# RFI Item 6 - Open Space Plan

# NMP | Landscape Architecture

Adamstown Boulevard - Phase I

RFI Response - SDZ22A/0007  
September 2022

# RFI Item 2.e & 3.b - Permanent Boundary Treatment Plan

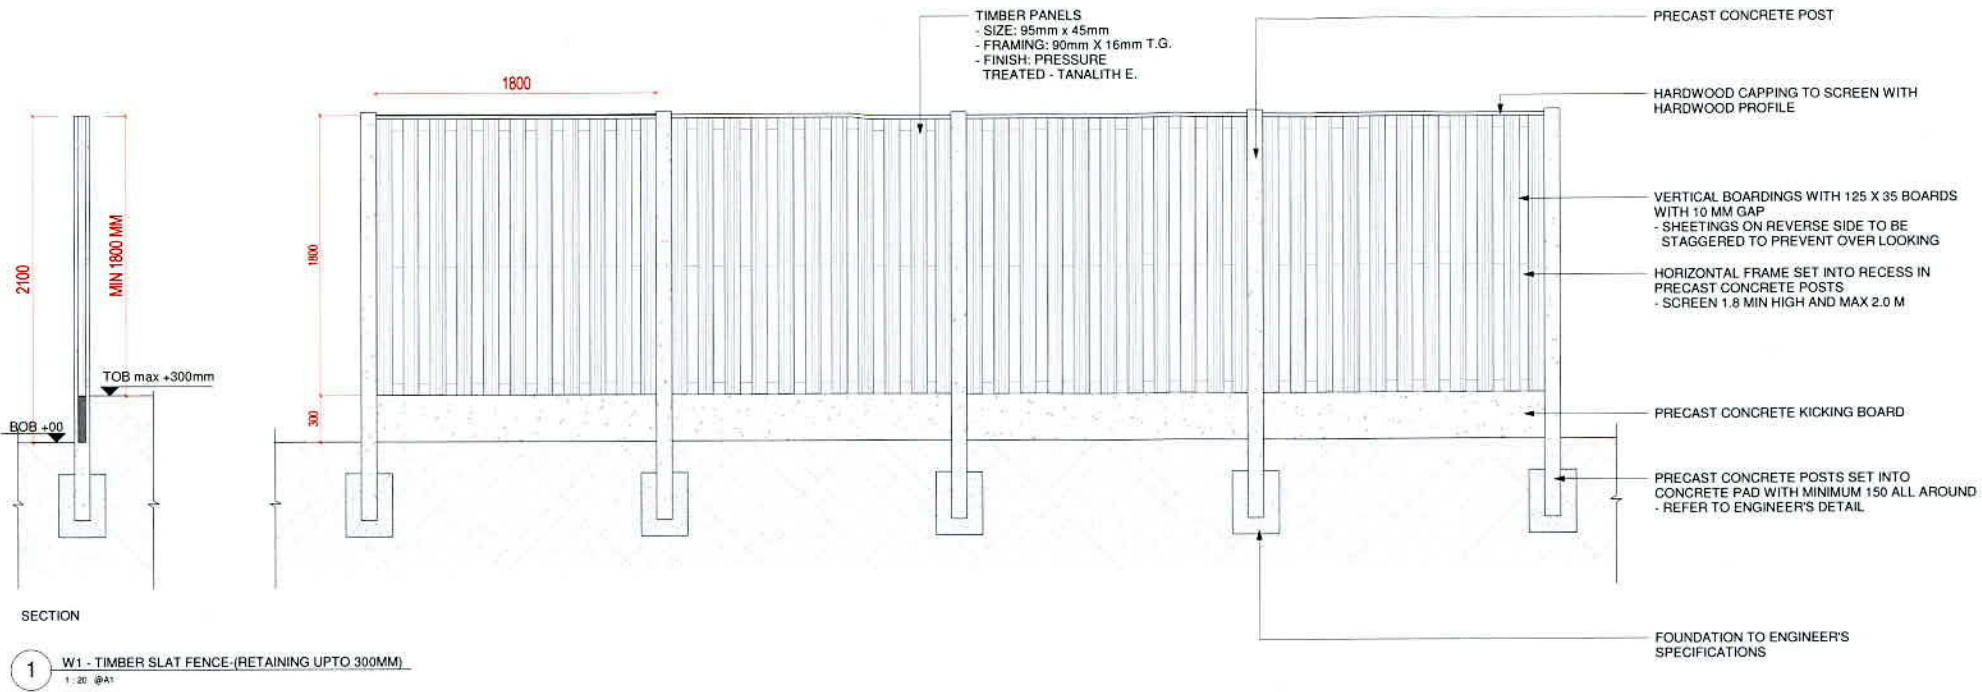
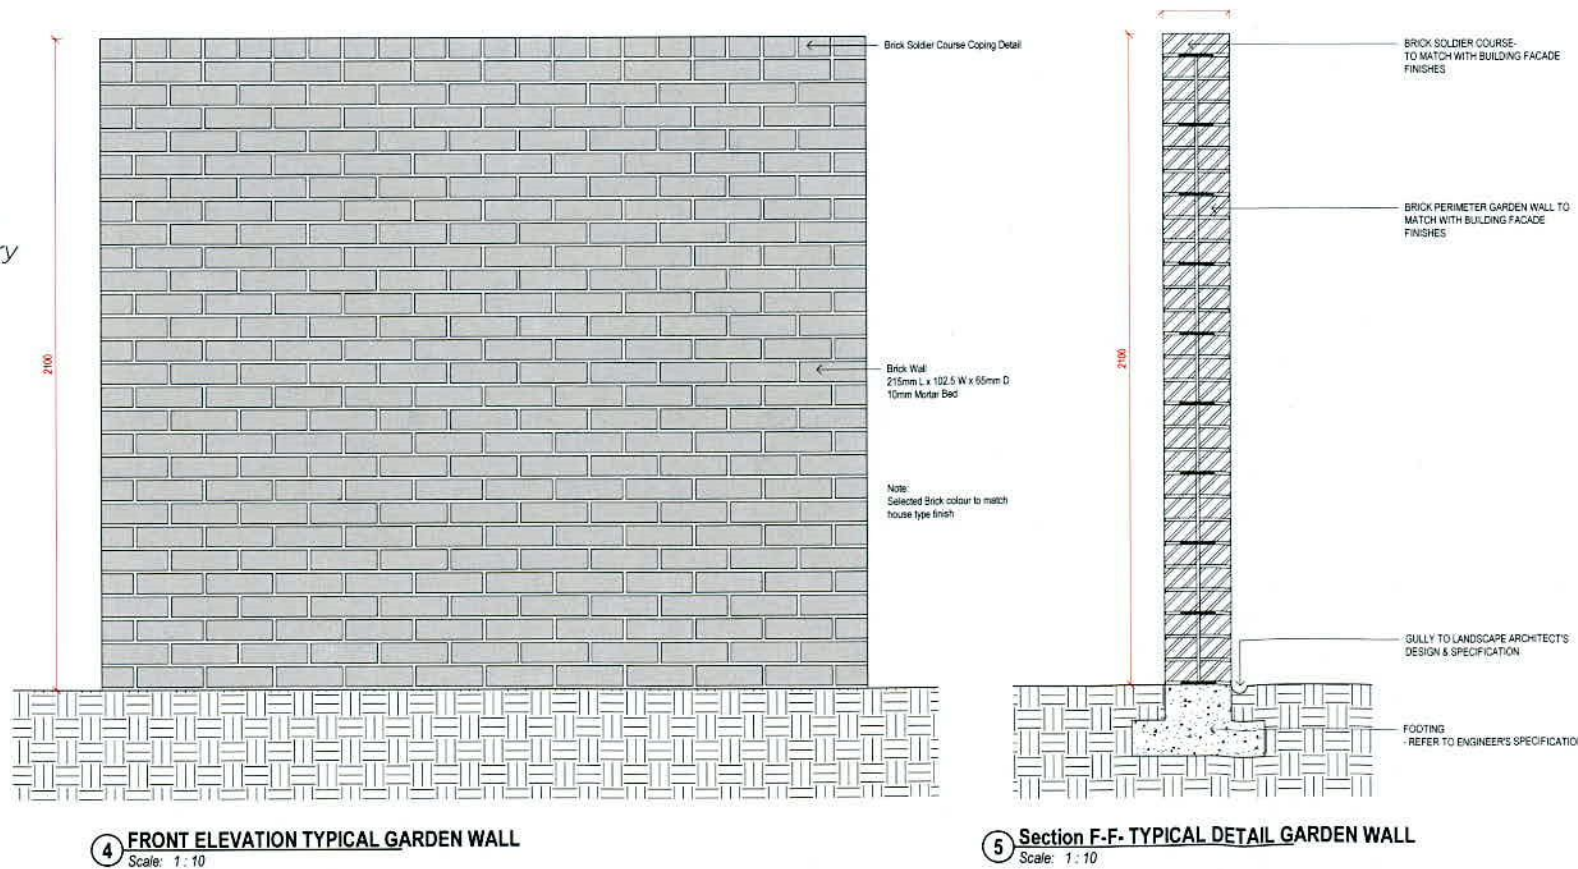
**3.b The applicant is requested to provide revised boundary treatment details / landscaping details for the boundary of the properties close to the hedgerow to the west**

Timber Slat Fence-  
Foundation Suitable for  
Hedgerow Boundary

Block Garden Wall-  
Foundation Unsuitable  
for Hedgerow Boundary

Refer to *L1-101- Permanent Boundary Conditions* plan. The permanent boundary treatment to the back garden of the terraces along the hedgerow are to be a hit & miss timber fence with precast concrete posts. This treatment was selected in lieu of a block wall to mitigate the impact of the foundation along the hedgerow. The pier foundations have a minimum affect on the root protection zone in comparison to the strip foundation due to the reduction of soil disturbance & minimizing area of the foundation. The pier foundations of the timber fence are to be spaced every 1.8 meters. The boundary will provide sufficient security & privacy for the residences while minimizing the footings along the root barrier.

## RFI Item 2.e

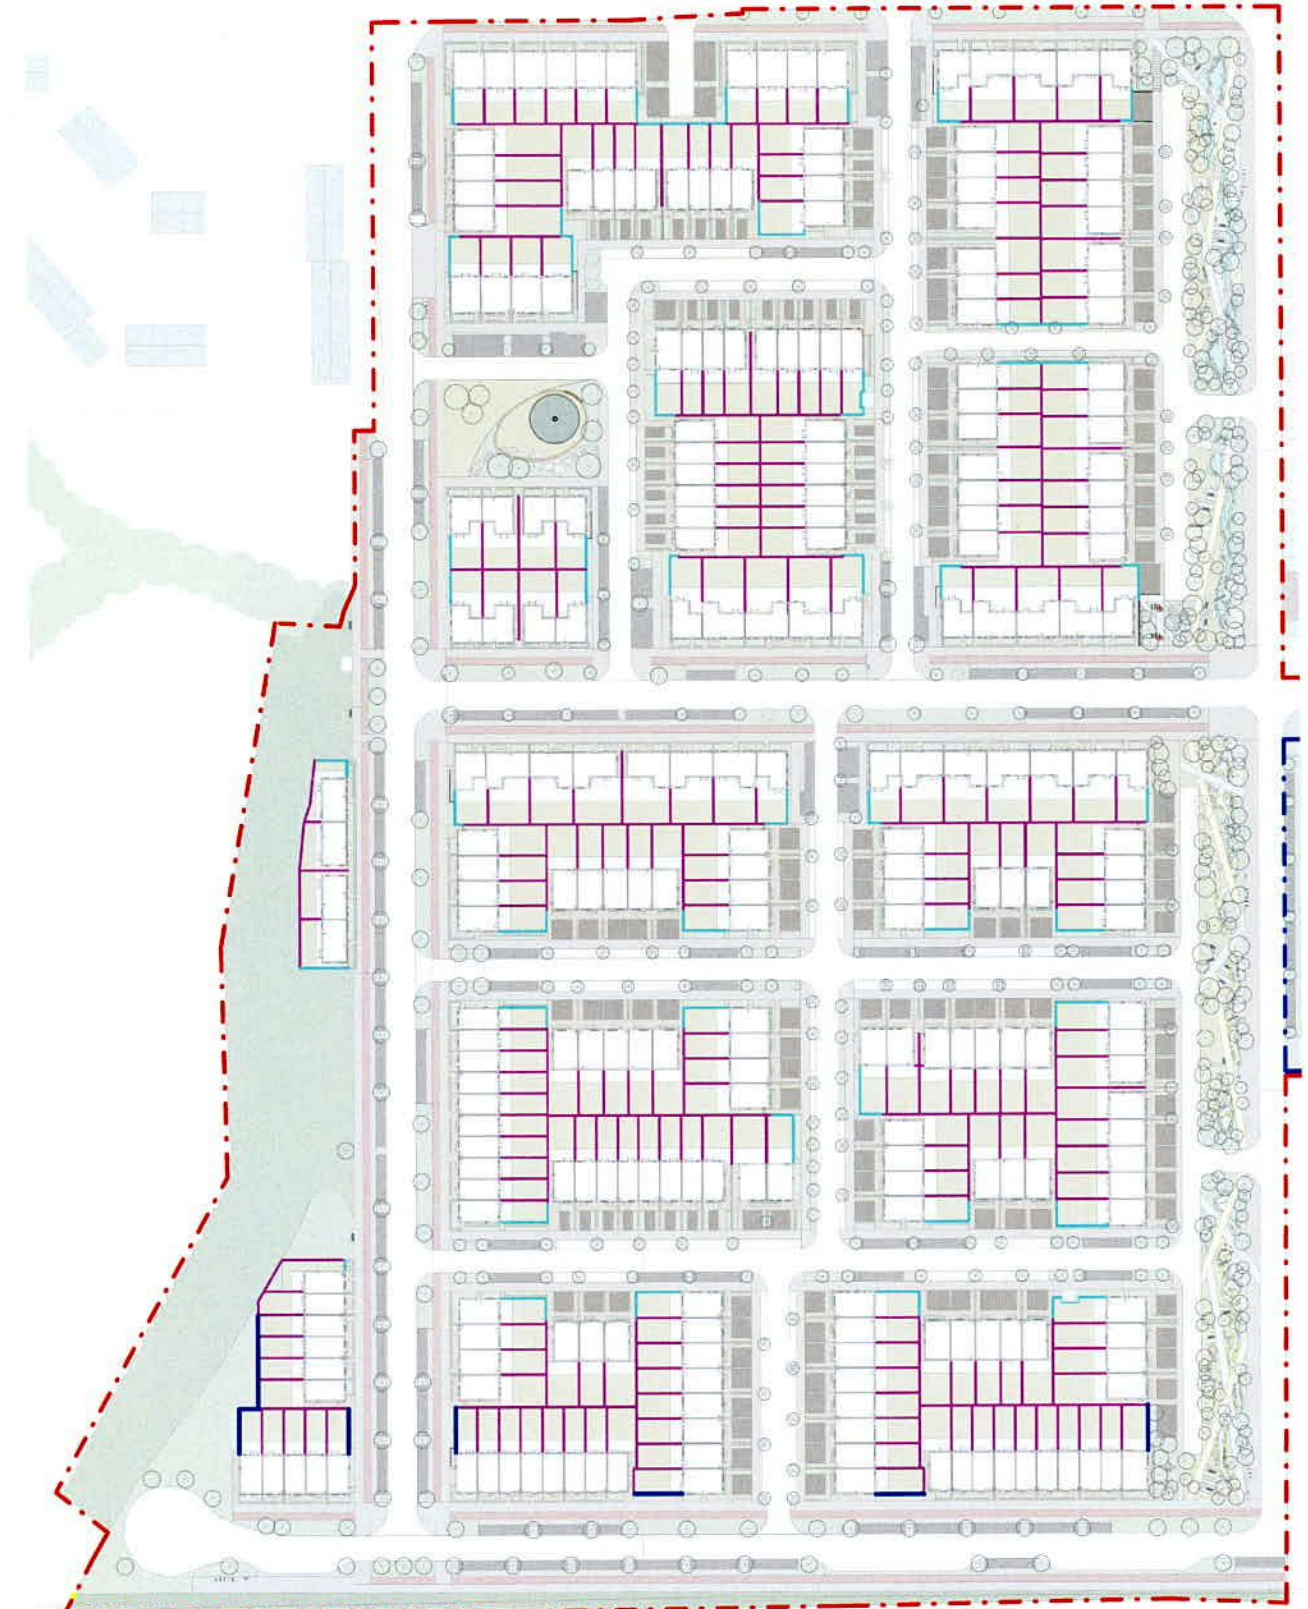
A statement outlining recommended acoustic control measures that should be incorporated into the design and construction of the proposed houses and/or site to ensure the use will not create adverse noise impacts on the occupiers. This should include parameters for walls, glazing, doors and ventilation for the proposed development.

Per the acoustics report by iAcoustics, the primary noise sources impacting the development is caused by road traffic and rail noise from the railways line running East-West to the south of the site. In order to mitigate noise exposure in private gardens due to train passing, we recommend a 2.4m solid block wall to be added at critical locations. Increasing the garden walls from 1.8m standard to the 2.4 block wall creates a noise barrier to rear gardens near the railway line.

In reference to RFI item no. 3b, the acoustic wall measure needs to be balanced with the careful protection of the hedgerow root protection area. Please refer to drawing no. *L1-101 - Permanent Boundary Conditions* for the proposed location of the block garden walls (at 2.4m and 1.8m) and timber slat fence (1.8m). Details for the block garden wall, please refer to architectural drawing A-45011.
